NEWMAR CORPORATION WARRANTY DEPARTMENT

TECHNICAL SERVICE BULLETIN						
DATE ISSUED	MODEL YEAR(S) AFFECTED	MODEL(S) AFFECTED	TSB #			
06/15/01	2001	OPTION SPECIFIC	223			
BRAND		TYPE				
All <input type="checkbox"/>	American Star <input type="checkbox"/>	Kountry Star <input type="checkbox"/>	Dutch Star <input type="checkbox"/>	All <input type="checkbox"/>	T T <input type="checkbox"/>	F W <input type="checkbox"/>
NewAire <input type="checkbox"/>	Mountain Aire <input checked="" type="checkbox"/>	Kountry Aire <input checked="" type="checkbox"/>	London Aire <input checked="" type="checkbox"/>	C A <input type="checkbox"/>	D P <input checked="" type="checkbox"/>	D B <input checked="" type="checkbox"/>
<input checked="" type="checkbox"/> Air Conditioning & Heating				<input type="checkbox"/> Electrical Components		
<input checked="" type="checkbox"/> Appliances & Accessories				<input type="checkbox"/> Exterior Components		
<input type="checkbox"/> Cabinets & Furniture				<input type="checkbox"/> Interior Components

TECHNICAL BULLETIN

Subject: The Elimination of the "Eco-Valve" in all Fuel-Nozzles.

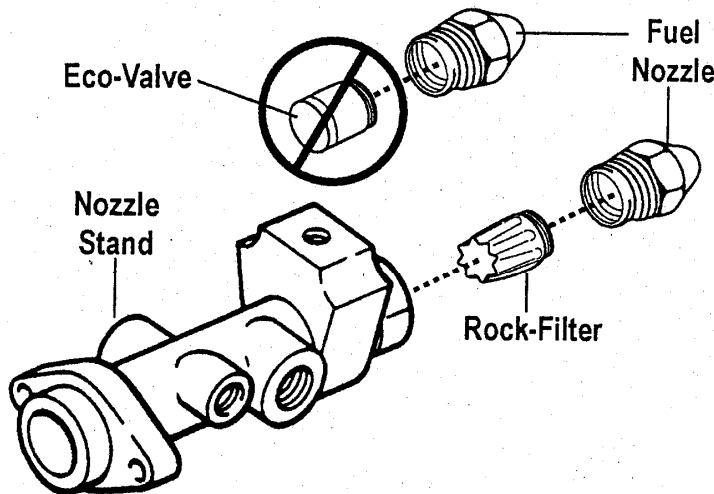
Vehicle Systems, Inc. has recently determined that the need for the "Eco-Valve" is no longer necessary. The Eco-Valve is an integral part of the Diesel-Burner's Fuel-Nozzle (part # WPE-886-41V) and is designed to instantly shut-off the flow of diesel fuel to the Diesel-Burner, once the internal Solenoid-Valve has been electrically deactivated. We have determined that this valve adds no benefit to any of our RV Hydronic Heating Systems; due to the discovery that our current combustion chamber temperatures automatically burn-off any residual diesel fuel that may be left behind once the Solenoid-Valve closes. This Eco-Valve was initially designed for Residential applications where Boilers typically operate at lower temperatures and thus may require the need for such a product.

Therefore, from this date forth all of our new production Diesel-Burners (i.e. RV Hydronic Heating Systems) will be supplied without the Eco-Valve, as well as all replacement Fuel-Nozzles (new part # WPX-886-41A). If your company presently stocks any existing Fuel-Nozzles, (old part # WPE-886-41V) with Eco-Valves, please contact our Service Department at 1-800-685-4298 for replacement Rock-Filters, see Figure below for details.
